Report to the Future Melbourne (Planning) Committee

Planning Permit Application: TP-2020-427 Yarra River adjacent to Lower Promenade, Southbank (north of 4 Riverside Quay)

DELEGATED PLANNING APPLICATION REPORT

Application number:	TP-2020-427
Applicant:	Australian Venue Co
Address:	Yarra River adjacent to Lower Promenade, Southbank (north of 4 Riverside Quay)
Proposal:	Buildings and works for a temporary pontoon to be used as a restaurant, construction and display of signage and a reduction of bicycle parking
Date of application:	26 June 2020
Responsible officer:	Kate Yuncken

DATE	27/01/2021	SCALE	1:100	DWG No. TP02 REVISION J
DRAWN	J.L.	CHECKED		
JOB No.	19006

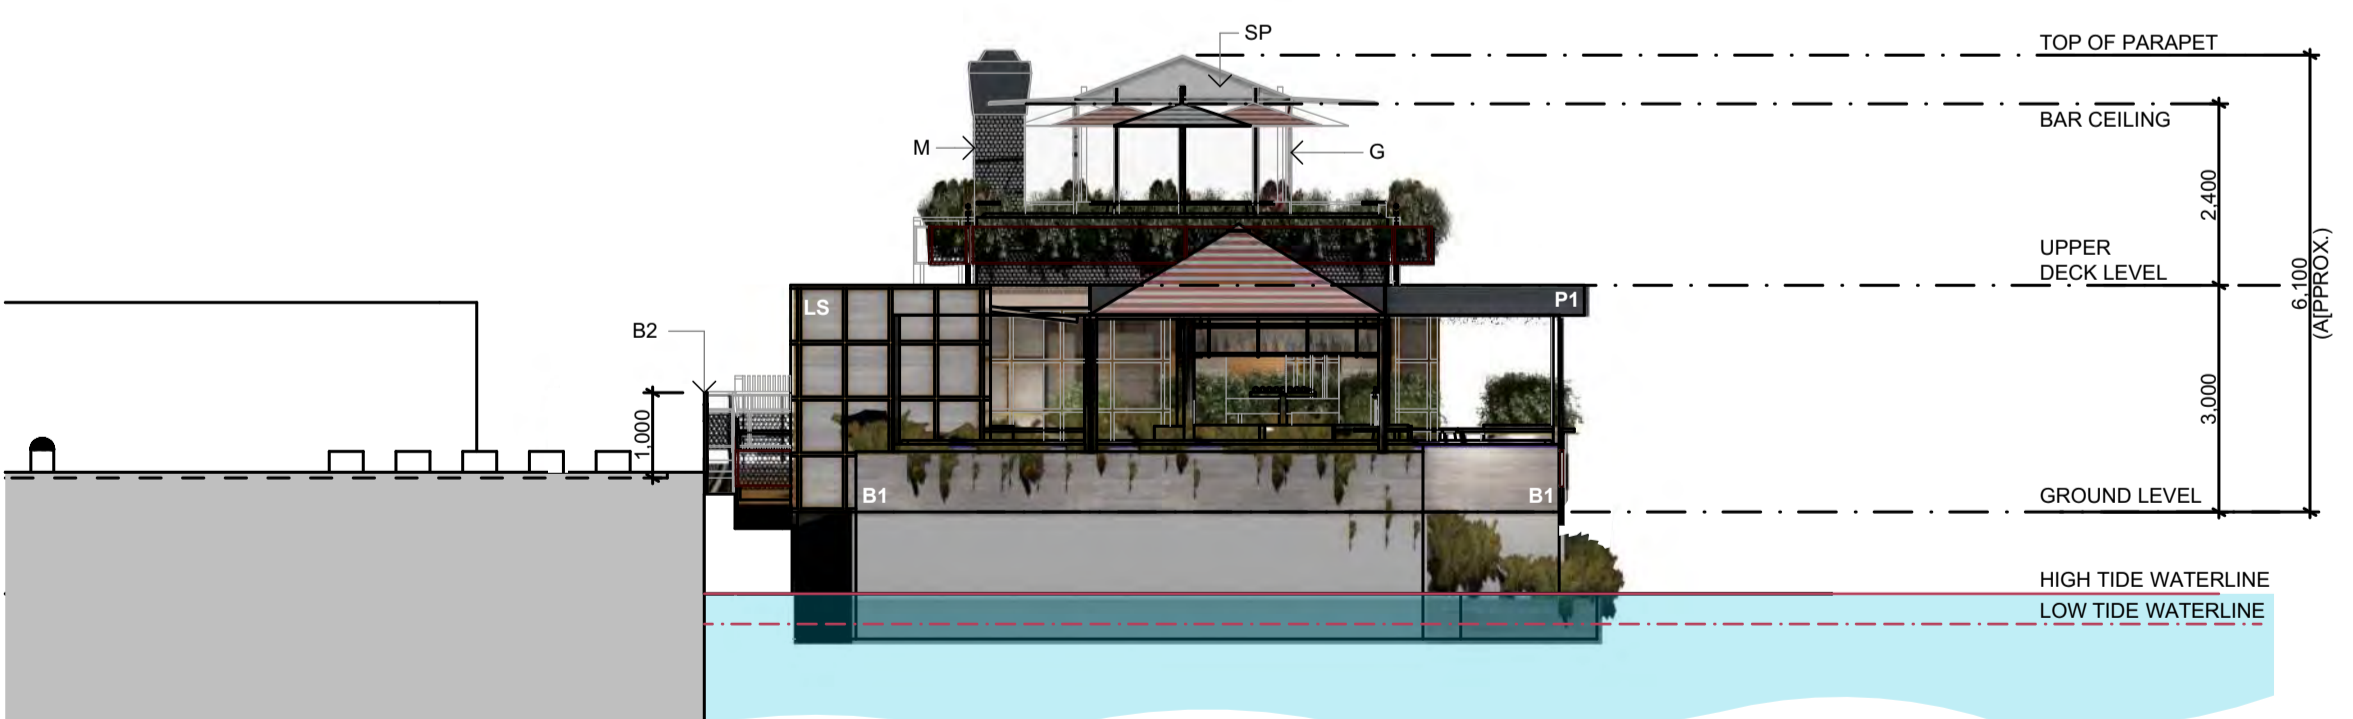
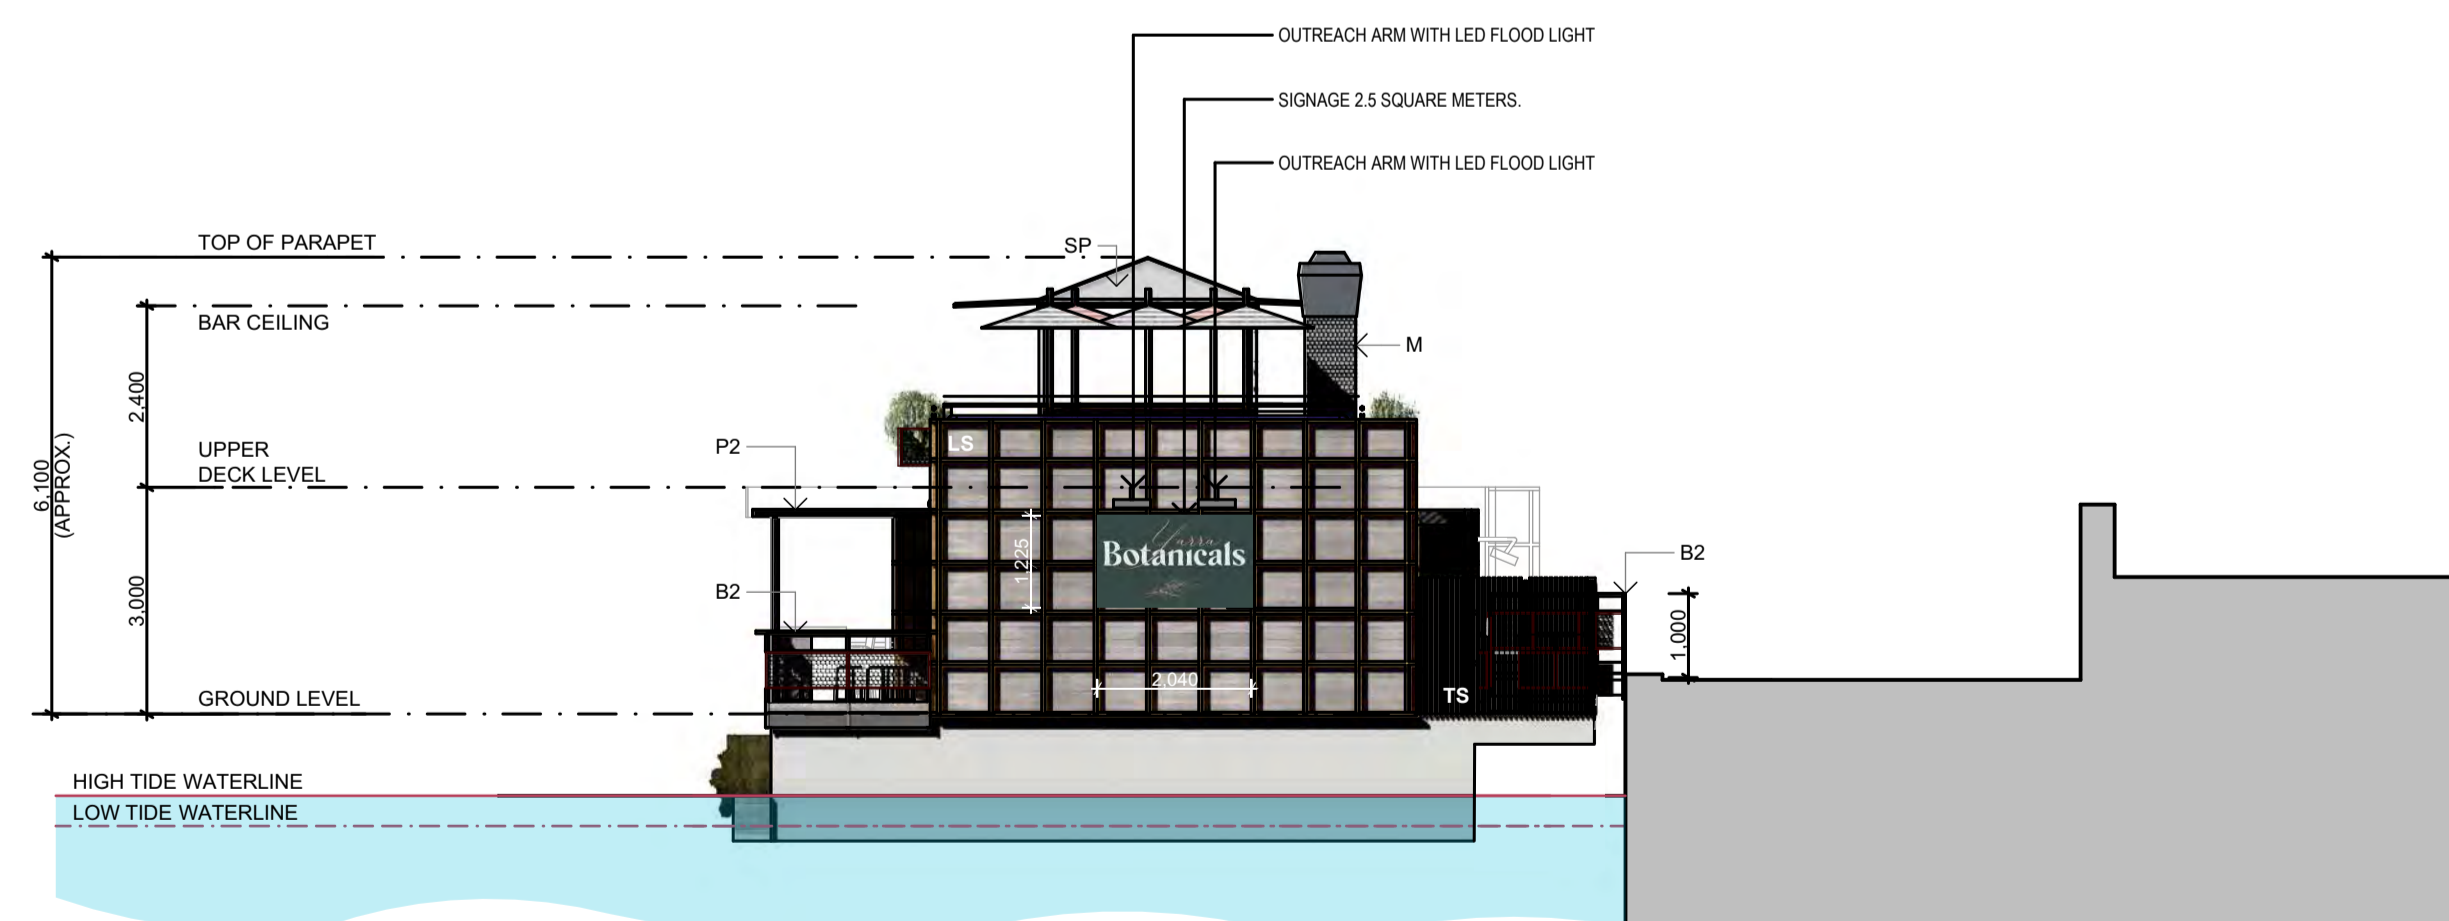
The proposed works are supported subject to a minor change to the west elevation, discussed below. The following elements of the proposal are encouraged by the Urban Design Principles at Clause 21.01 (Urban Design within the Capital City Zone) and the Design Objectives of Design and Development Overlay 60:

The proposed signs (subject to the south elevation sign being reduced) are acceptable, having regard to the relevant policies of the Planning Policy Framework and Local Planning Policy Framework, for the following reasons:

1. Prior to the commencement of the development excluding early works, and site preparation works or as otherwise agreed with the Responsible Authority, an electronic set of plans drawn to scale and an updated development summary, must be submitted to the Responsible Authority, generally in accordance with the plans prepared by Burton and Carter Pty Ltd dated 27 January 2021 but amended to show:
